M24128T-FCU package mechanical data modifications

This errata sheet applies to the M24128T-FCU, that is the 128 Kbit serial I²C bus EEPROM delivered in WLCSP four balls.

The impacted part number is M24128T-FCU6T/TF.

Figure 3. D and E back side view

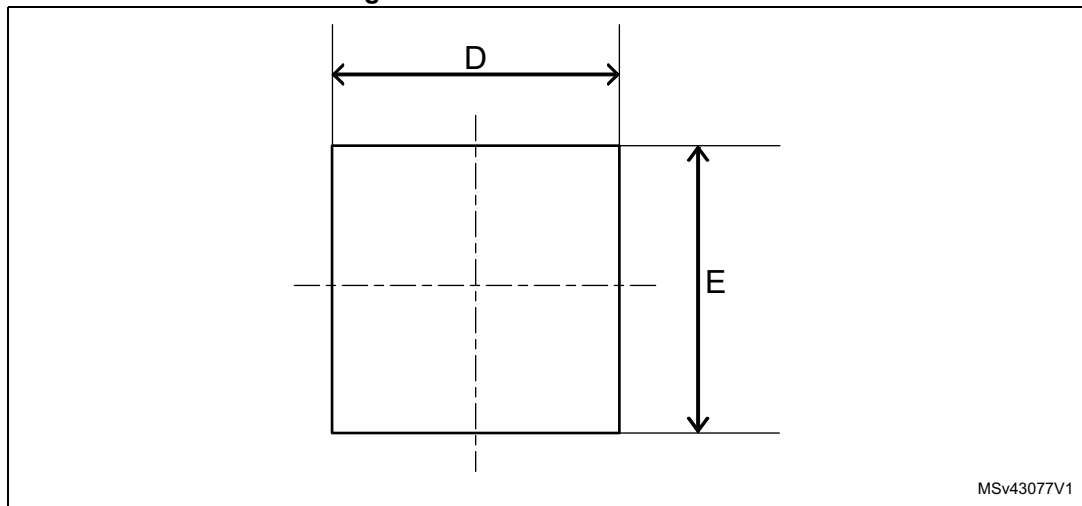
This document refers to the changes of dimensions D and E (see [Figure 3](#)) described in the M24128T-FCU datasheet, in tables detailing the dimensions of the Ultra Thin WLCSP 4-bump package.

D and E values must be modified to correct the following mistake:

- The D and E values on M24128T-FCU datasheet corresponding to front side view (ball side) as shown in [Table 1](#), instead of back side view (marking side view) as shown in [Table 2](#).

Symbol	Millimeters			Inches		
	Min	Typ	Max	Min	Typ	Max
D	0.831	0.851	0.871	0.0327	0.0335	0.0343
E	0.831	0.851	0.871	0.0327	0.0335	0.0343

Figure 4. D or E side view

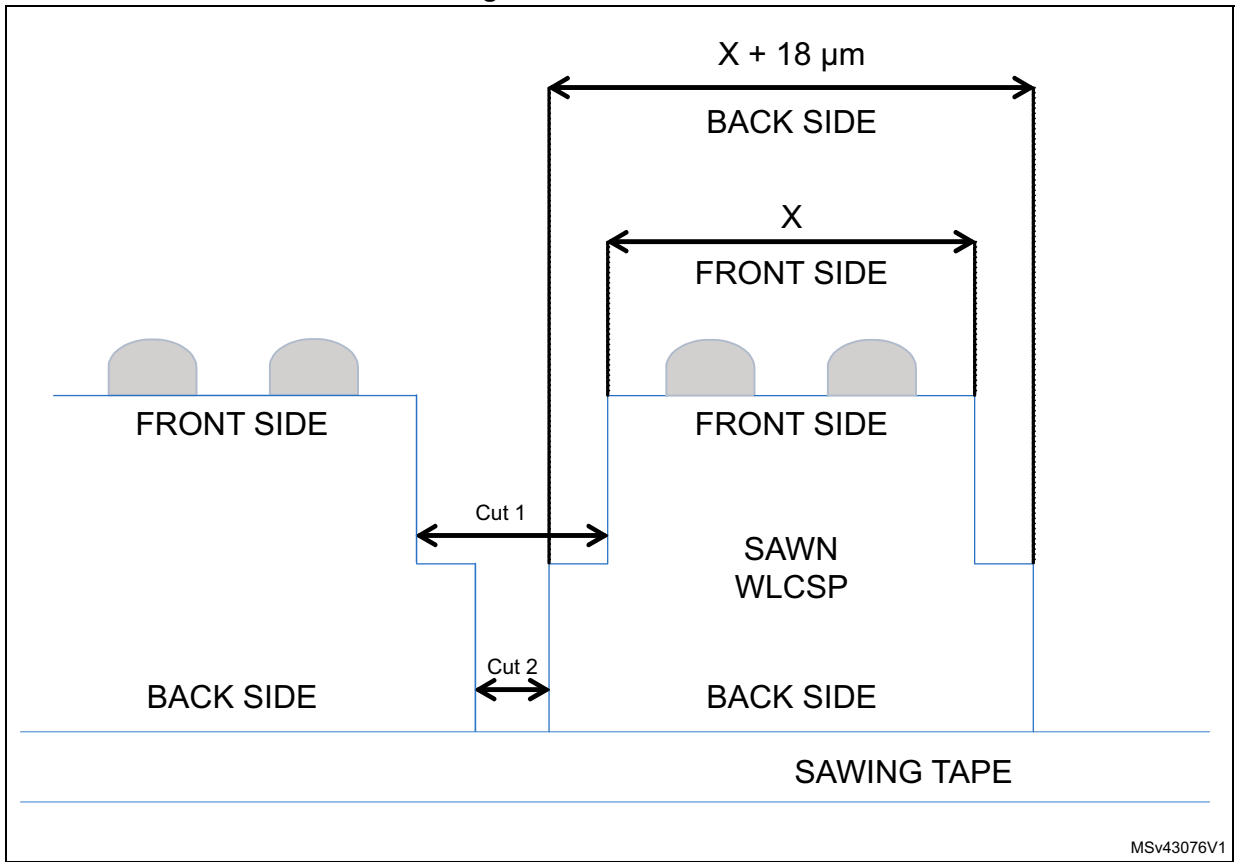
The difference between back side and front side dimension is 18 μm (0.018 mm). This difference is due to two-step sawing process, where cut 1 and cut 2 are performed with blades having different thickness (see [Figure 4](#) in which X represents D or E and it has the same value and tolerance).
